From: Tesfaye, Getachew
Sent: Tuesday, July 31, 2012 8:37 AM
To: ArevaEPRDCPEm Resource
Subject: Non-Proprietary Presentations and Affidavit for July 30th Mtg - RAI 403 and SGTR Event
Attachments: Affidavit RAI 403 Presentation (2).pdf; Non-Proprietary RAI 403 Meeting July 30 2012 _Redacted.pdf

Public Meeting to Discuss Closure of U.S. EPR™ FSAR Open Items on RAI 403 and to Discuss Reanalysis of SGTR Event

Meeting Purpose and Background

RAI 403, Question 15.06.05-61

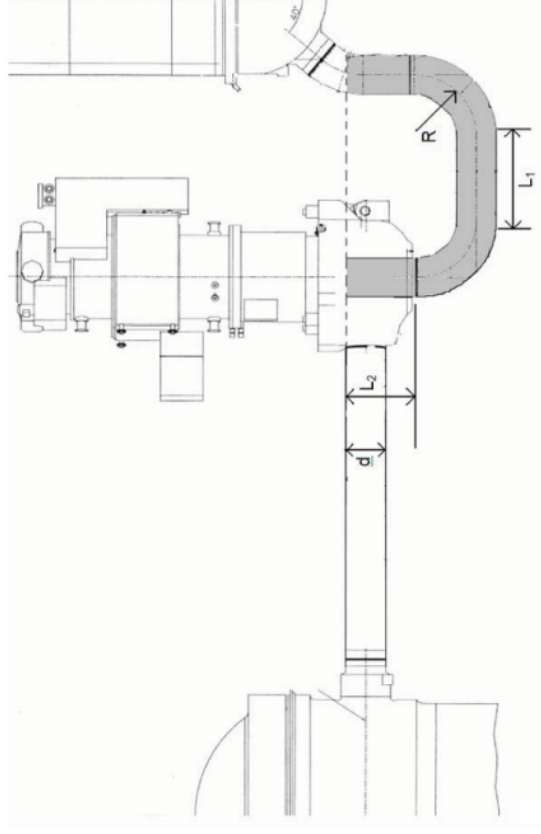
- ▶ In response to Question 15.06.05-29, the applicant did not provide an assessment of the amount of condensate generated by reflux condensation as was requested. Instead, predictions for the liquid content in control areas defined as “steam generator (SG) outlet plenum,” “loop crossover pipe,” and “cold leg” were presented. Provide a calculation of the amount of condensate generated by reflux condensation accounting for conditions with emergency feed water (EFW) supply present for two or more SGs.

- ▶ The staff requests a mass balance accounting for the steam generated in the core by decay heat, steam lost out the break, steam condensed in the SGs, condensate in countercurrent flow returned to the reactor vessel hot leg, condensate collected on the SG, loop crossover pipe, and cold leg, condensate lost out the break, and condensate transported to the vessel downcomer.

- ▶ The staff requests a description of situations involving stratified conditions in the cold leg and downcomer regions.

SGTR Overfill – No LOOP

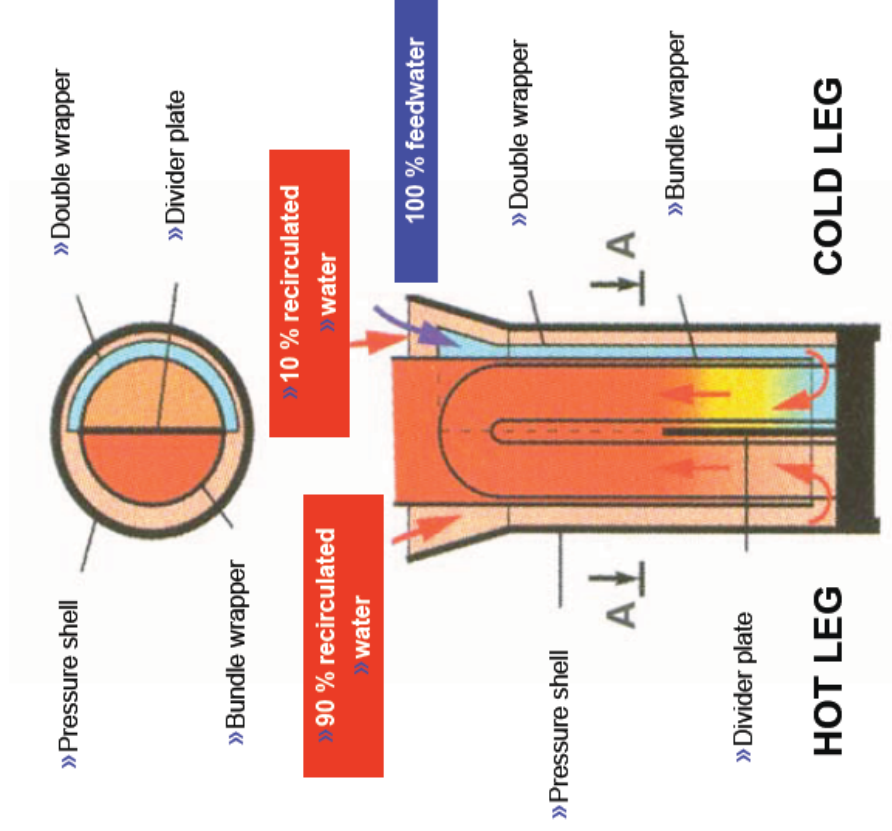
- ▶ **Issue:** The analysis of SGTR without LOOP for the overfill criterion was not performed, which could be more limiting than the analyzed LOOP case

- Continued MFW would be more detrimental from SG overfill standpoint
- ▶ **The SGTR limiting overfill analysis to be performed with the assumption of no LOOP**

- ◆ Availability and continuous injection of MFW a significant contributor to the ruptured SG inventory and overfill
 - ◆ SGTR radiological analysis not impacted
